**Department of Energy**  
Albuquerque Operations Office  
P.O. Box 5400  
Albuquerque, New Mexico 87115

The enclosed information is provided in response to a request made by Sandy Wastler in a telephone conversation with Richard Richey of my staff on March 10, 1988. We hope this information will be beneficial in your staff's review of the Green River Final Remedial Action Plan.

W. John Arthur, III  
Project Manager  
Uranium Mill Tailings Project Office

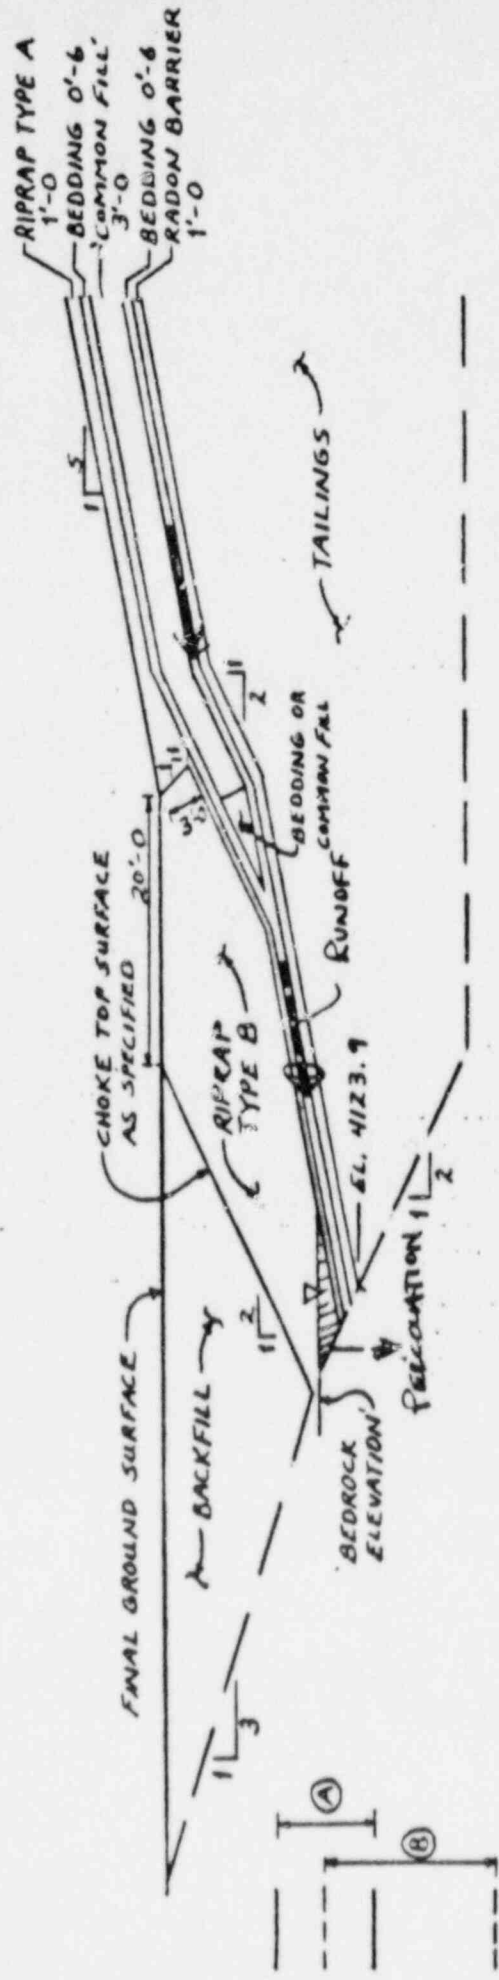
2 b) Regarding poring calculations, please see the attached note. The issue of seepage accumulation in the trenches has not been previously addressed. The minimum observed saturated conductivity of the bedrock is  $7 \times 10^{-9}$  cm/sec, 700 times the maximum infiltration rate. We therefore do not consider accumulation of seepage above this unit to be possible.

Figure 1 shows a section through the edge of the proposed cell and the adjacent host material. Water will be shed from the top of the cell through the bedding material and riprap. All infiltration is expected to penetrate the common fill where it is present, rather than drain laterally through the upper bedding layer. Infiltration reaching the lower bedding layer will either penetrate the clay cover or flow through the bedding to the bedrock contact. Runoff reaching the bedrock will accumulate until the saturated area of the rock and the driving force of water ponded in the trench produce discharge balancing the rate of runoff from the pile.

In summary, we expect ponding in the sub-surface trench to increase infiltration by a maximum of 50% over a maximum of 0.8% of the pile, or 0.4% overall. This calculated increase is likely to be too large because of the following conservative assumptions:

Figure 2 - Schematic Diagram of Areas Affected by Ponding in the Trench

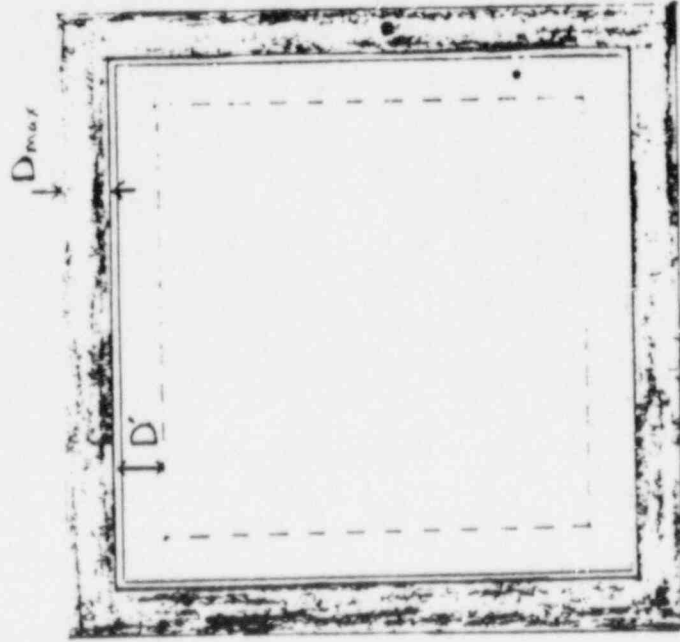
This runoff will create a ring of infiltration surrounding the pile (see Figure 2). Should ponding occur, the minimum infiltration rate will be the lower bound on bedrock permeability acting under a minimum gradient of 1:

The area over which this infiltration occurs will be governed by the circumference of the pile (C), the width of the ponded zone  $D_{\max}$ , and the proportion of the ponded area in contact with the bedrock. The fraction of the ponded area allowing infiltration depends on the packing of the bedding material against the bedrock. Infiltration would enter the bedrock through the open pore spaces, and expand into regions blocked by grains of bedding material. We therefore expect the bedrock immediately below the contact area to be completely saturated, giving an effective-to-ponded infiltration area ratio near 1. As a conservative estimate, we assumed that the infiltration area will be limited to the open pore space area in the bedding material at the contact, giving an effective-to-ponded area ratio equal to the bedding layer porosity of .25. The effective infiltration area is approximately

$$\Rightarrow D_{\max} = 75 \text{ cm}$$

With a 2:1 excavation sideslope, this infiltration zone would produce a maximum ponding depth of 37 cm at the contact of the radon barrier with the bedrock. Current simulations of the proposed design predict a ponding height of 16 cm in the bedding layer. The maximum additional ponding in the trenches would increase vertical gradients through the barrier, and therefore infiltration around the edge of the cell. With the current 5:1 cover sideslope and a bedding thickness of .5 ft., this additional ponding would occur in a 100 cm (3.6 feet) skirt surrounding the cell (see Figure 3). The fraction of the cell area affected by this ponding is then:
